**RELICENSING STUDY 3.3.8**

**COMPUTATIONAL FLUID  
DYNAMICS MODELING IN THE  
VICINITY OF THE FISHWAY  
ENTRANCES AND POWERHOUSE  
FOREBAYS**

**ADDENDUM**

**Northfield Mountain Pumped Storage Project (No. 2485)  
and Turners Falls Hydroelectric Project (No. 1889)**

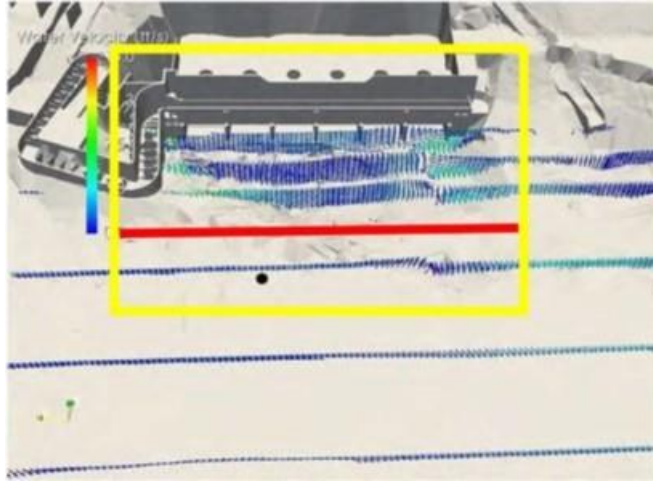
Comment: For Production Runs 5-1 through 5-5: Figure 1 shows the area to be revised for several figures in the report whereby each of these types of figures should be zoomed into the yellow box and another cross section at the red line should be added.

*These type of figures will be modified as requested in the study addendum.*

Figure 2.2-3: Comparison of depth-averaged water velocities between the two sensitivity analysis model runs

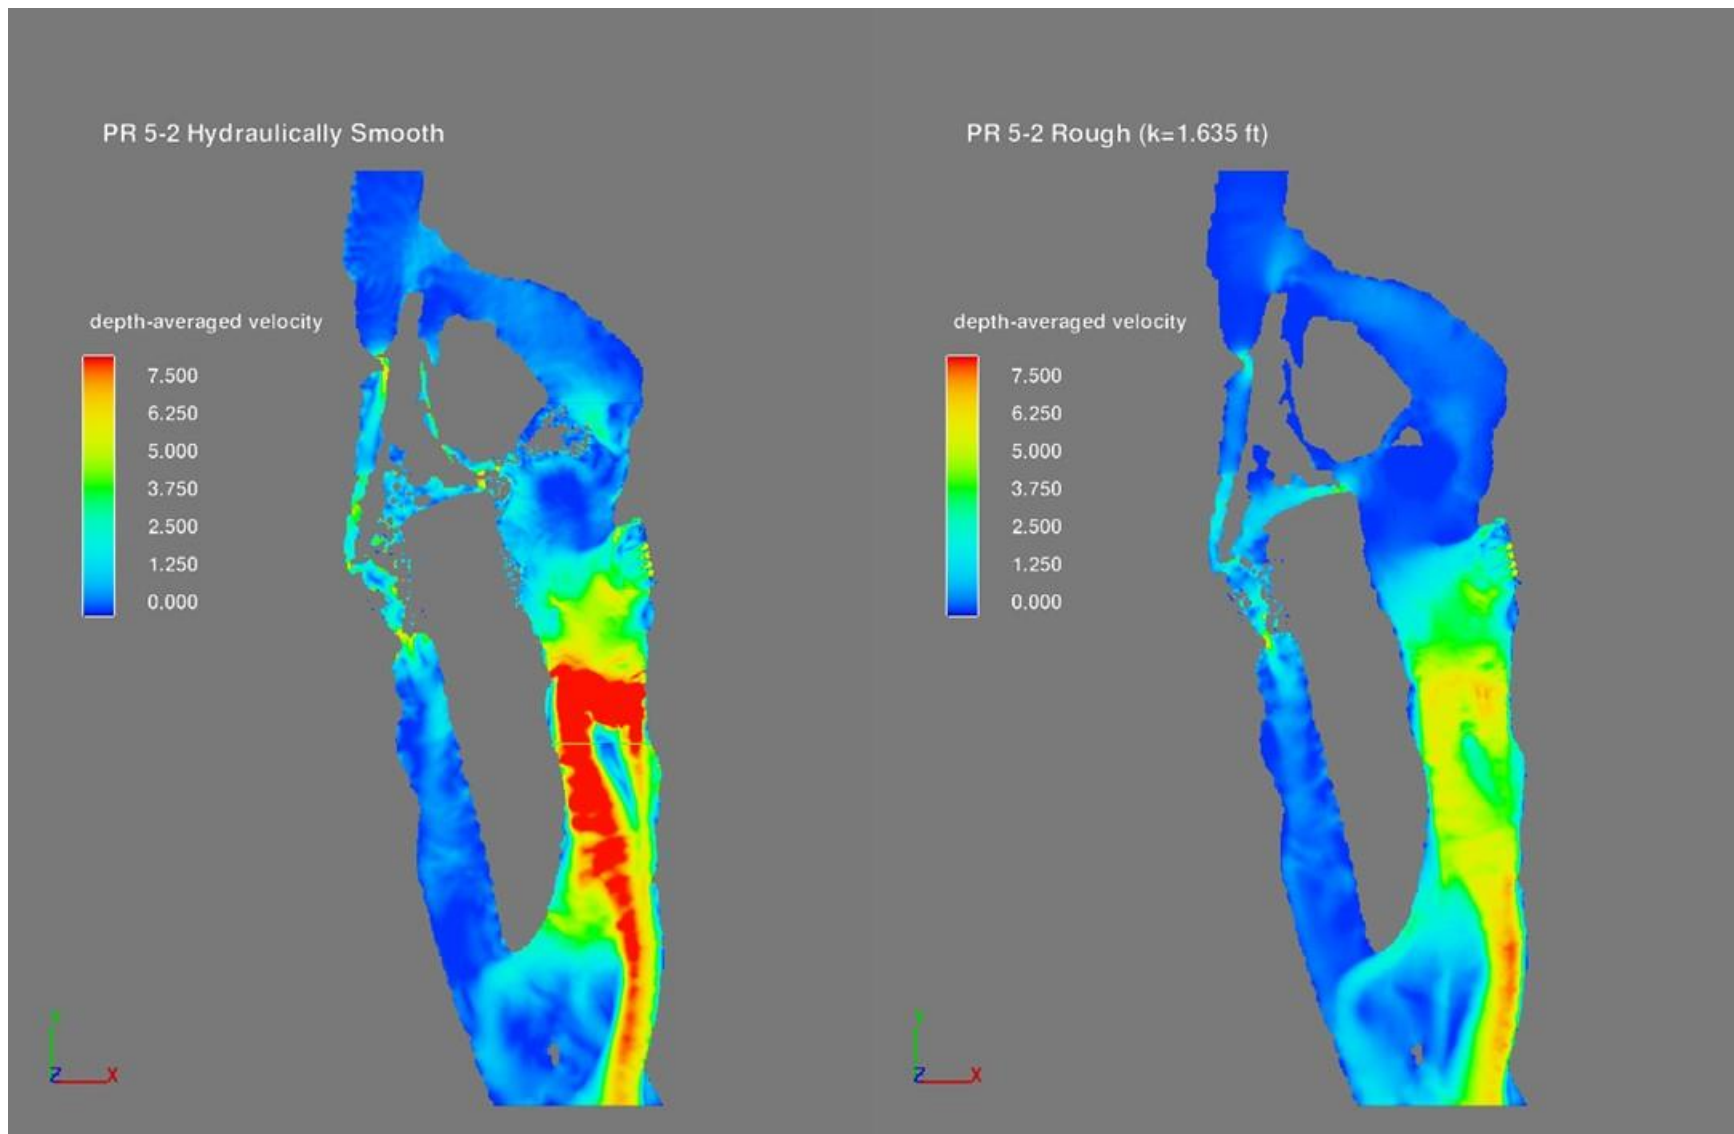
Comment: *As noted on pg. 2-2 and elsewhere, Gomez and Sullivan Engineers (GSE) have modeled all physical boundary conditions as hydraulically smooth. Implicit in this model simplification is the lack of calibration to real flows (which is distinct from the verification process). Hydraulically smooth boundaries are generally appropriate for shallow, low velocity turbulent flows. However, many of the modeled reaches/locations are of sufficient velocity and depth, with sufficient channel roughness, to be characterized as hydraulically rough. Hydraulically rough surfaces may produce a very different velocity distribution*

than hydraulically smooth surfaces; and velocity distributions are a key correlation to fish movement (along the bank, throughout the river, in the power canal, and approaching fishway entrances). As an example, this simplification may relate to the discrepancy between measured and simulated velocities downstream of the fishway entrance cited on pg. 6-5 of the study report. Unfortunately, the influence of this simplification on the overall modeling effort cannot be quantified a priori. The Service appreciates that software limitations, as described by GSE staff on a March 31, 2016 conference call on this report, may prevent incorporating accurate roughness elements throughout the model. Nevertheless, additional work is needed to reduce the uncertainty in the 3D distribution of velocity in GSE's model. If GSE believes that the hydraulically smooth assumption has a limited influence on the model results, we request that FL provide a sensitivity analysis that demonstrates this limited influence by comparing a hydraulically smooth boundary to one with appropriate channel roughness on a representative subsection of the overall model.

[Figure 2.2-3](#) shows depth-averaged water velocities in the entire model area for the original (hydraulically smooth) and bed-roughened (k=1.635 ft) model results. There are noticeable differences in depth-averaged velocity, particularly in the riffle area downstream of Cabot station. The velocities are noticeably lower (approximately 1-2 fps) with the roughened channel than they were with the smooth bed assumption. We did not conduct a more quantitative analysis as we believe these results show that the model is relatively sensitive to bed roughness adjustments.

The model appears to be relatively sensitive to bed roughness changes when comparing k=0 (hydraulically smooth) to k=1.635 ft (roughly equivalent to n=0.035 in a 15-foot-deep channel). This may have implications for the other model runs that have been completed to-date.

**Figure 2.3-1: Station No. 1 Scenario 1-1 Intake Rack Approach Velocity**

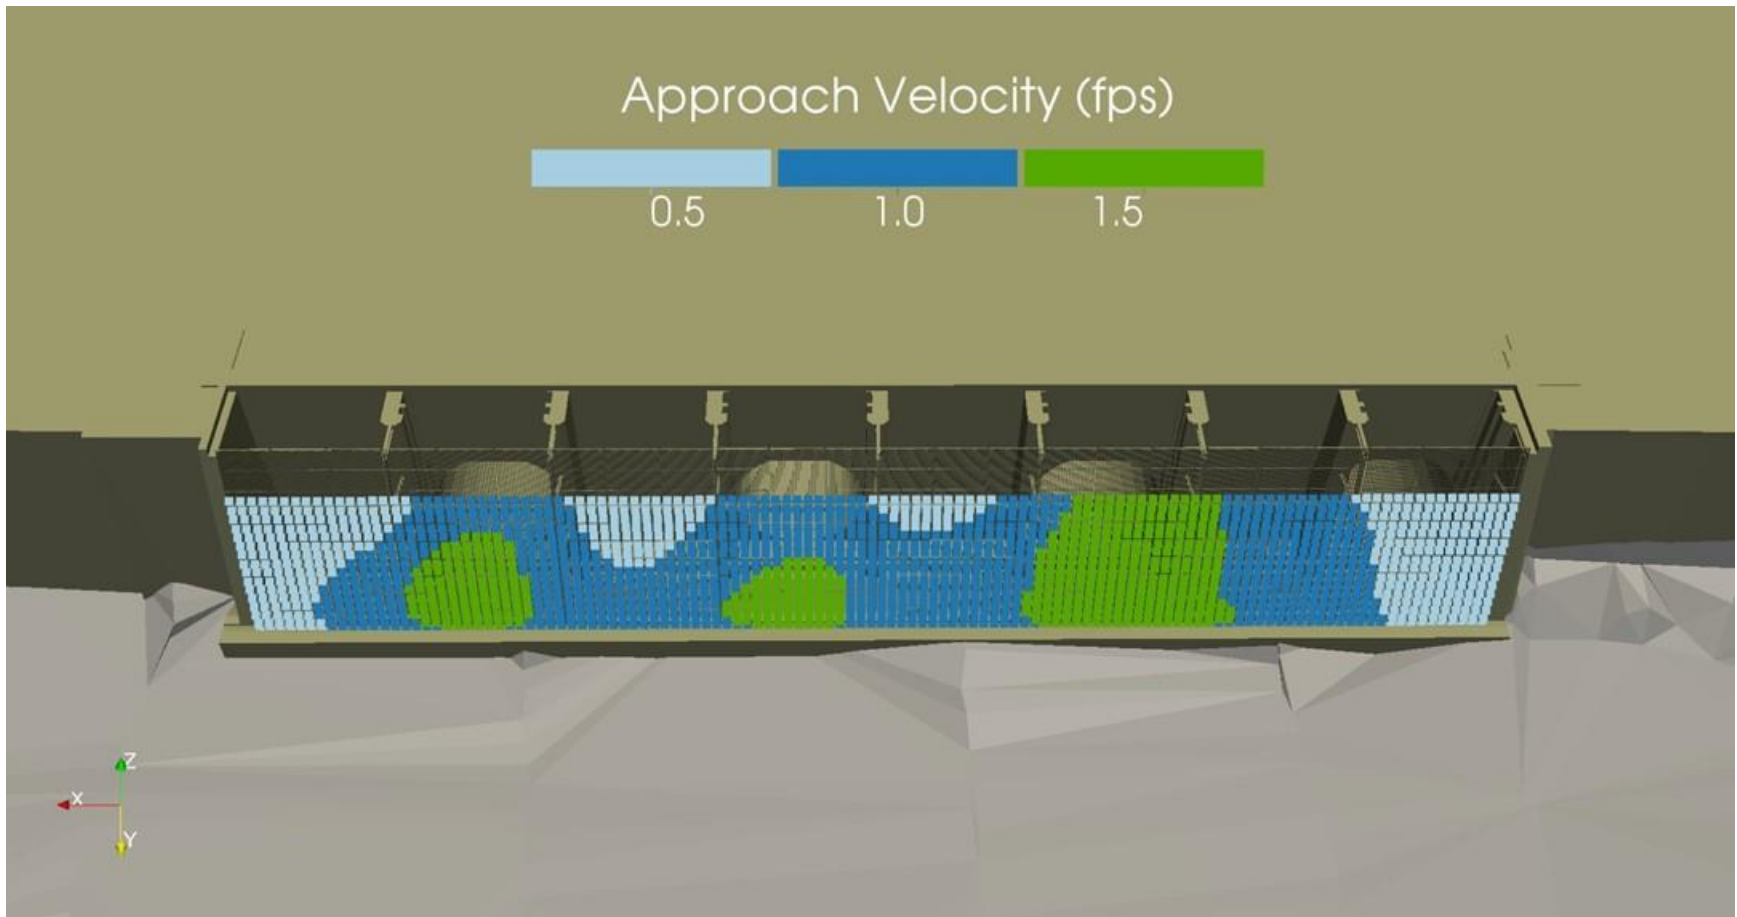
Comment: *GSE provided colorized vector plots of the intake velocities in front of the racks at Station No. 1 and Cabot Station. To better evaluate the hazards of impingement and entrainment, we request that FL provide contour line maps of approach velocities 1 foot in front of the racks for scenarios 1-x and 3-x with color lines clearly labeled in 0.5 fps increments (or finer).*

[Figure 2.3-1](#) shows the approach velocity as 0.5 fps-incremented color bins in front of the intake for Scenario 1-1. [Figure 2.3-2](#) shows the approach velocity for Scenario 1-2. [Figure 2.3-3](#) shows the approach velocity for Scenario 1-3.
